Chevron at Newberry and Tower Road

Final Redevelopment Plan

April 9, 2024

Final Redevelopment Plan

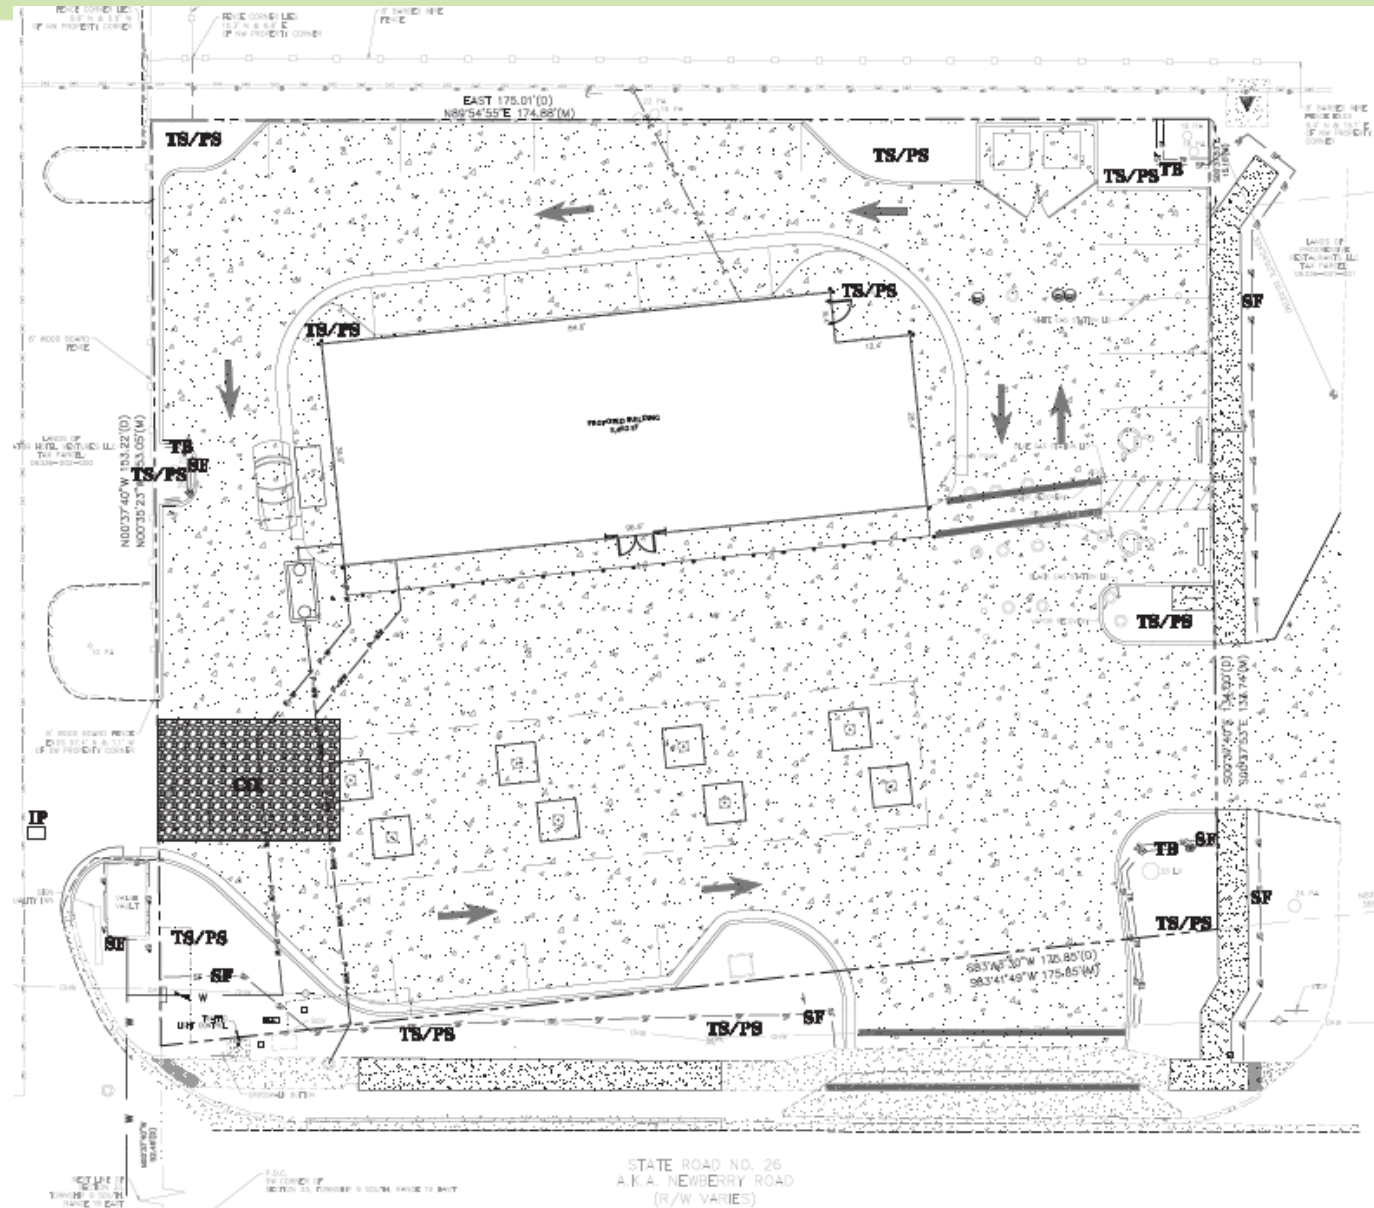
Bases for Denial:

- 405.05(b) Definable Edges
- 405.07(c)(4) Parking located in front
- 405.07(e) Pedestrians crossing vehicular areas
